THE CITY OF PLEASANTON

**ADDENDUM NO. 2**

**Emergency Generator Replacement, CIP Nos. 26162 & 26250**

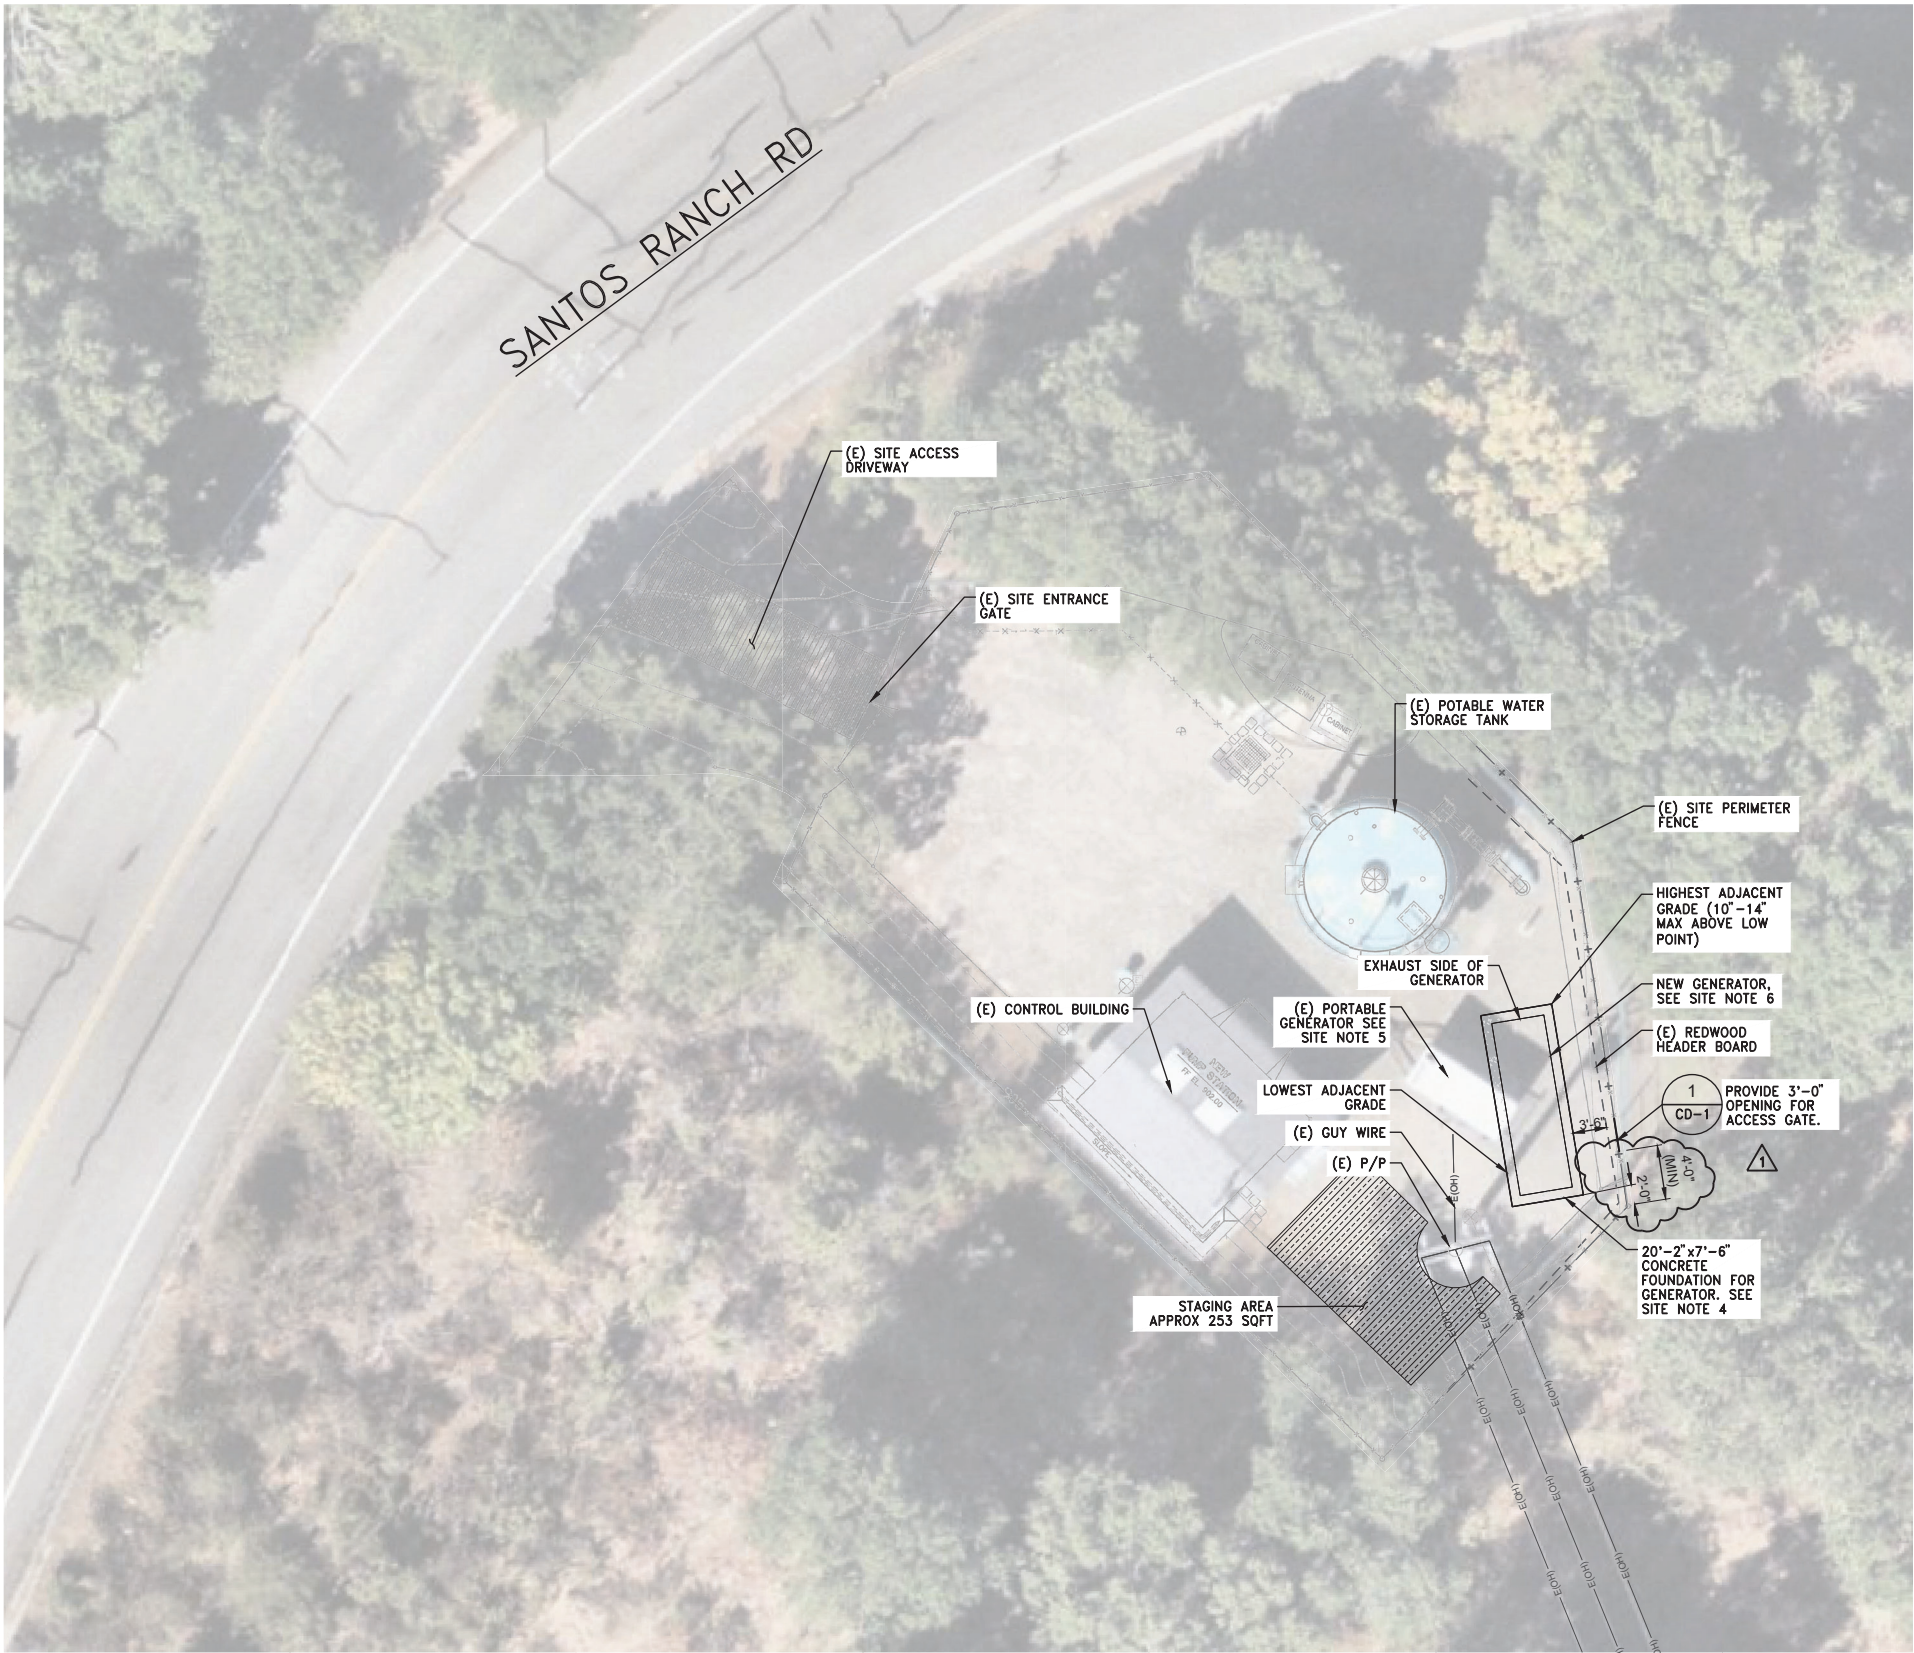
| <b><u>Item</u></b> | <b><u>Drawing</u></b> | <b><u>Description</u></b>                                                                                                                                                                                                                                                                                                                                                 |
|--------------------|-----------------------|---------------------------------------------------------------------------------------------------------------------------------------------------------------------------------------------------------------------------------------------------------------------------------------------------------------------------------------------------------------------------|
| 1.02               | C-1                   | REPLACE sheet C-1 in its ENTIRETY with the attached Drawing C-1, Revision 1.<br><br>Summary of Revisions: Added a new note to remove the existing indoor generator, including the exhaust system piping, duct shrouds, power and control wiring, and conduits. Added information regarding radiator wall louver blank-off.                                                |

| <b>Number</b> | <b>Question (Q) and Answer (A)</b>                                                                                                                                                                                                                                                                                                                                                                                                                                                                                                                                                                                                                                                                                                         |
|---------------|--------------------------------------------------------------------------------------------------------------------------------------------------------------------------------------------------------------------------------------------------------------------------------------------------------------------------------------------------------------------------------------------------------------------------------------------------------------------------------------------------------------------------------------------------------------------------------------------------------------------------------------------------------------------------------------------------------------------------------------------|
| Q1.05         | <p>Q: Will the existing generator enclosure structure remain at the S-7 site? How does the City want the existing louver replaced?</p> <p>A: The existing overhead ventilation ducting and sheet metal paneling above the generator in the S-7 Sewer Lift Station generator room shall remain. The Contractor may coordinate with the City for temporary removal, as necessary, to demolish the existing generator exhaust system. The existing louver shall remain and be blanked off on the interior face. Additional notation has been added to Drawing C-4 as part of this Addendum. Additional notation regarding louver blank-off has also been added to Drawing C-1 for the generator room at the Laurel Creek Booster Station.</p> |

| 900 SANTOS BOOSTER PUMP STATION SITE IMPROVEMENTS PLAN |

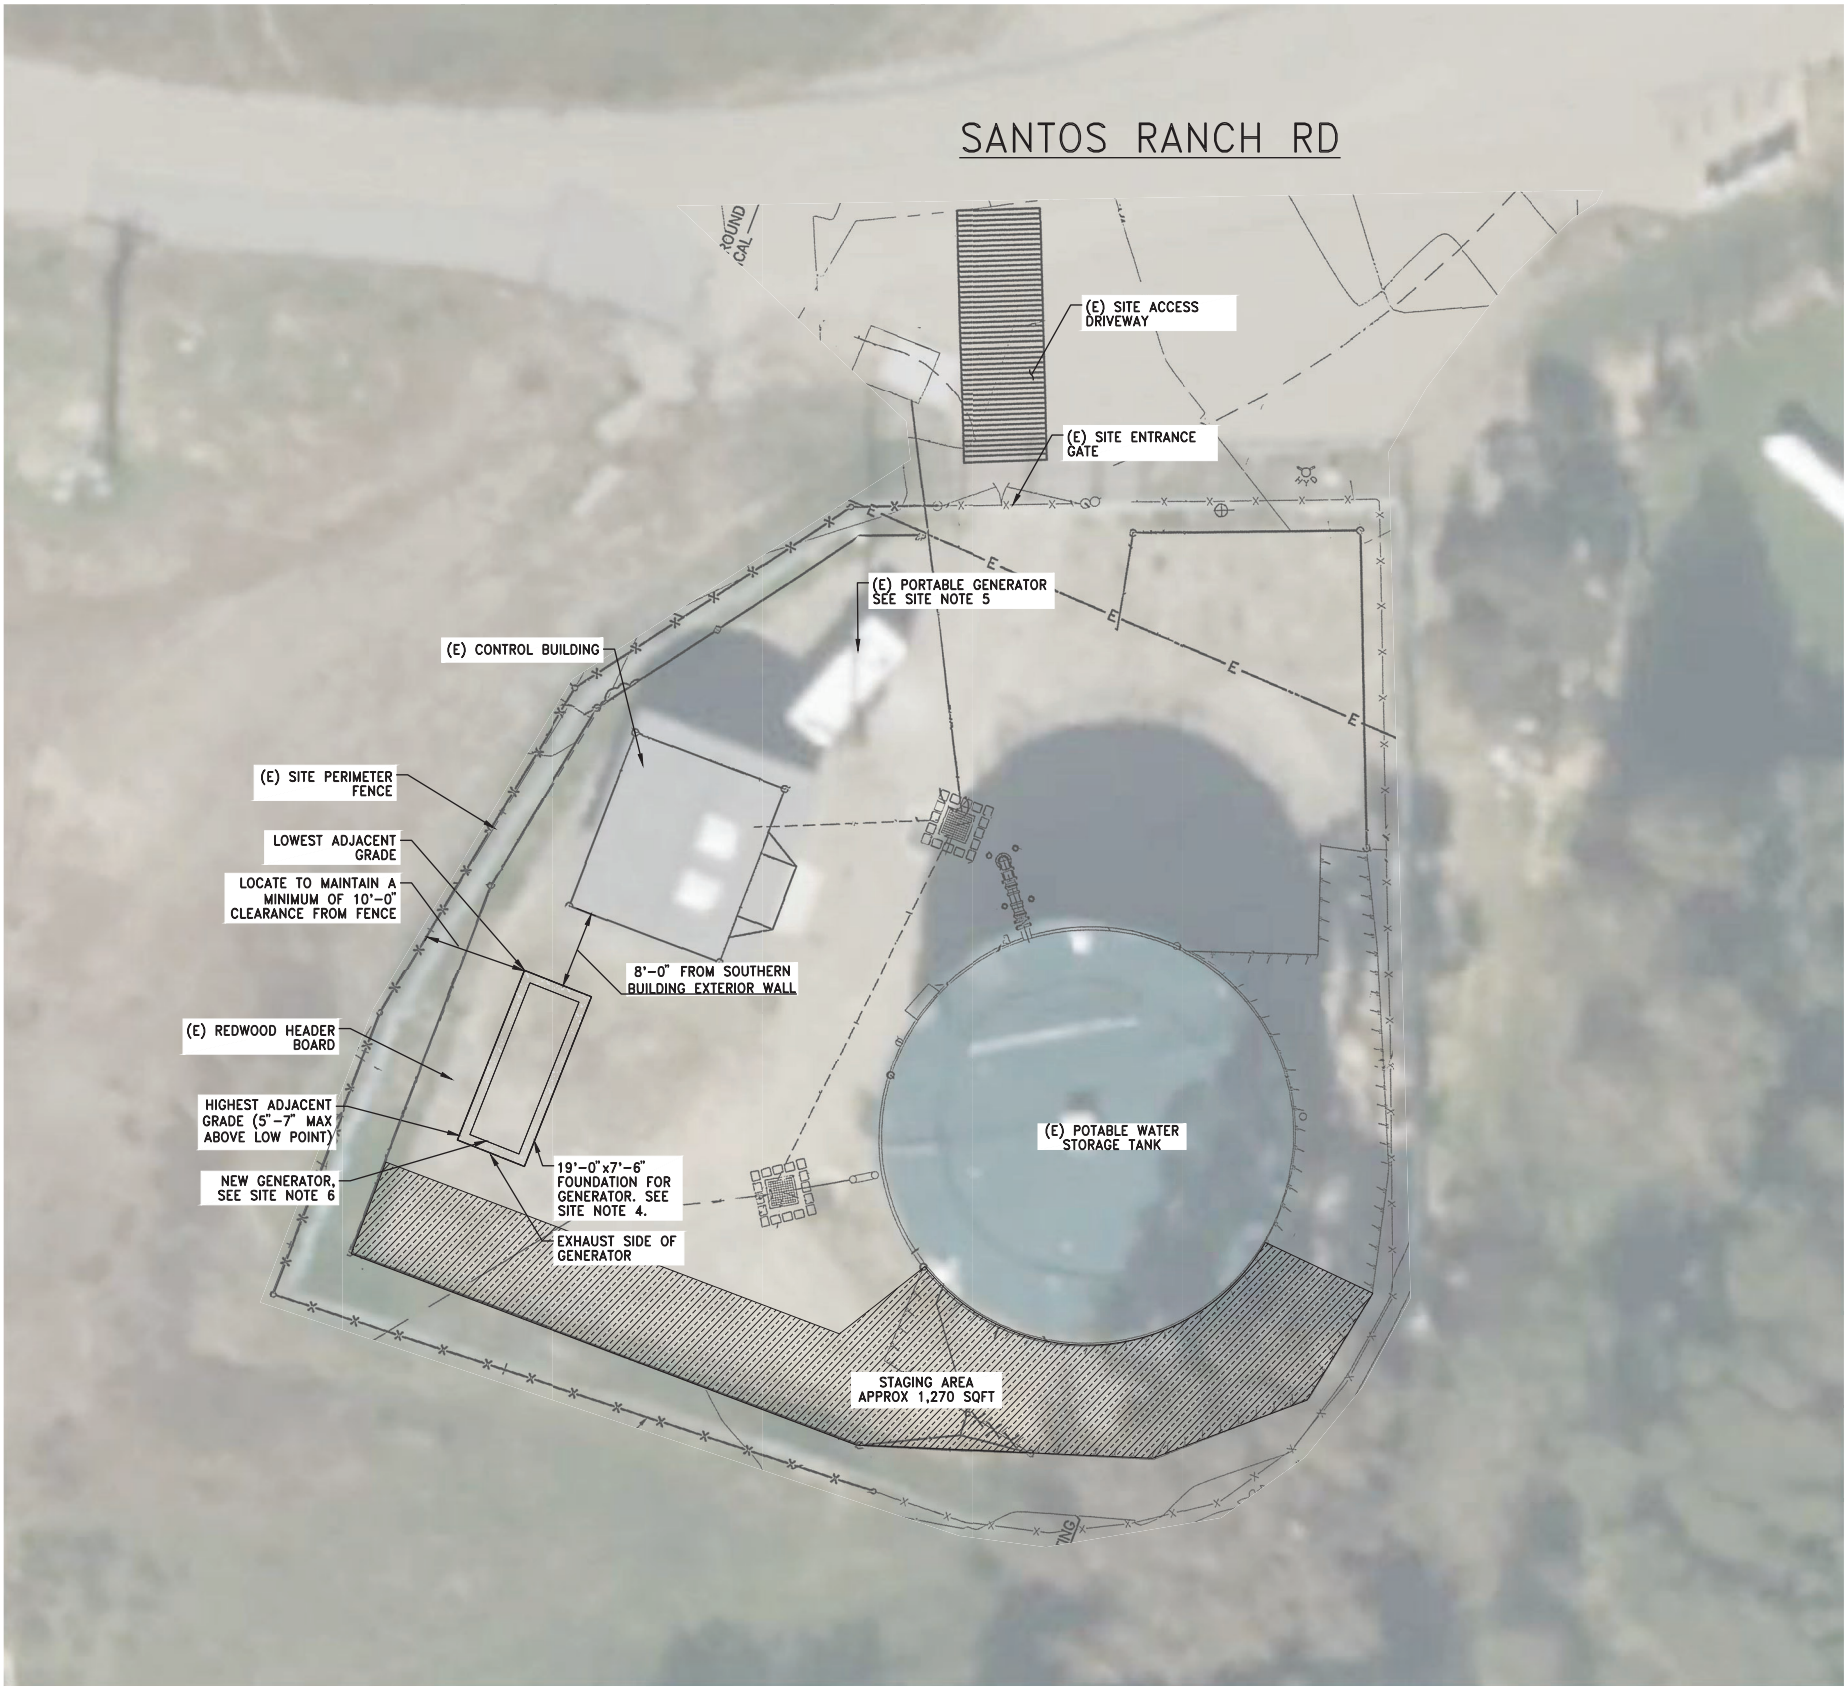
| <b><u>Item</u></b> | <b><u>Drawing</u></b> | <b><u>Description</u></b>                                                                                                                                                                                                                                                                                                                                                 |
|--------------------|-----------------------|---------------------------------------------------------------------------------------------------------------------------------------------------------------------------------------------------------------------------------------------------------------------------------------------------------------------------------------------------------------------------|
| 1.03               | C-2                   | REPLACE sheet C-2 in its ENTIRETY with the attached Drawing C-2, Revision 1.<br><br>Summary of Revisions: Revised Note 1 to require verification of the gate location with the City representative. Revised Note 5 to clarify that the Contractor is responsible for providing and maintaining the temporary portable generator. Added a dimension for the gate location. |

| <b>Number</b> | <b>Question (Q) and Answer (A)</b>                                                                                                                                                                                                                                                                                                                                                                                                                                                                                                                                                                                                                                                                                                         |
|---------------|--------------------------------------------------------------------------------------------------------------------------------------------------------------------------------------------------------------------------------------------------------------------------------------------------------------------------------------------------------------------------------------------------------------------------------------------------------------------------------------------------------------------------------------------------------------------------------------------------------------------------------------------------------------------------------------------------------------------------------------------|
| Q1.01         | <p>Q: According to Drawing CD-1, the gate is to be replaced. Please clarify whether only the gate is to be replaced or whether the gate posts are also to be removed and replaced.</p> <p>A: Refer to Drawing C-2 for the new gate location, which is to be retrofitted into the existing chain-link fencing at the Santos 900 Booster Station site. The gate will require new posts. Additional notation has been added to Drawing C-2 as part of this Addendum.</p>                                                                                                                                                                                                                                                                      |

| <b>Number</b> | <b>Question (Q) and Answer (A)</b>                                                                                                                                                                                                                                                                                                                                                                                                                                                                                                                                                                                                                                                                                                                                                                                                                                                                       |
|---------------|----------------------------------------------------------------------------------------------------------------------------------------------------------------------------------------------------------------------------------------------------------------------------------------------------------------------------------------------------------------------------------------------------------------------------------------------------------------------------------------------------------------------------------------------------------------------------------------------------------------------------------------------------------------------------------------------------------------------------------------------------------------------------------------------------------------------------------------------------------------------------------------------------------|
| Q1.06         | <p>Q: Please clarify whether the portable backup generators currently being rented and located on site will remain on site during construction until the new generators are online, per Note 5 on Drawing C-2.</p> <p>A: The Contractor is required to provide and maintain temporary generators at each site for the duration of construction, until the permanent generators and all associated emergency power equipment, wiring, and local and remote status indications and alarming systems are accepted by the City and are fully functional and maintainable. The City will not continue its rental of the existing portable generators during construction. Refer to Specification Section 01010, Paragraph 1.01.A.4; and Specifications Section 16050, Paragraph 3.1.M, 3.1.M.7, and 3.1.N. Refer also to the revisions to Note 5 on Drawings C-2, C-3, and C-4 included in this Addendum.</p> |

1. PERMANENT GENERATOR AND GATE LOCATIONS ARE SHOWN FOR BIDDING PURPOSES ONLY. CONFIRM FINAL LOCATIONS WITH CITY REPRESENTATIVE PRIOR TO EXCAVATION FOR THE GENERATOR FOUNDATION AND INSTALLATION OF GATE AND GATE POSTS.

5. EXISTING PORTABLE GENERATOR MAINTAINED BY THE CITY TO BE REPLACED BY THE CONTRACTOR WITH THE CONTRACTOR'S TEMPORARY PORTABLE GENERATOR PRIOR TO CONSTRUCTION. COORDINATE SCHEDULING OF TEMPORARY GENERATOR REPLACEMENT WITH THE CITY AND ANY RELOCATION AS NECESSARY FOR SETUP. TEMPORARY SHUTDOWN AND DISCONNECTION OF GENERATOR POWER CABLES ARE ALLOWED FOR RELOCATION OF GENERATOR AS COORDINATED WITH THE CITY, BUT CABLES MUST BE RECONNECTED AND THE GENERATOR MUST BE PUT BACK INTO SERVICE IMMEDIATELY AFTER RELOCATION. THE CONTRACTOR SHALL REMOVE THE CITY'S PORTABLE GENERATOR AND POWER CABLES FROM THE SITE AND COORDINATE WITH THE CITY FOR DELIVERY ONCE THE CONTRACTOR'S TEMPORARY PORTABLE GENERATOR IS CONNECTED AND TESTED AND ACCEPTED BY THE CITY AS A FUNCTIONAL TEMPORARY EMERGENCY BACKUP POWER SUPPLY FOR THE SITE.
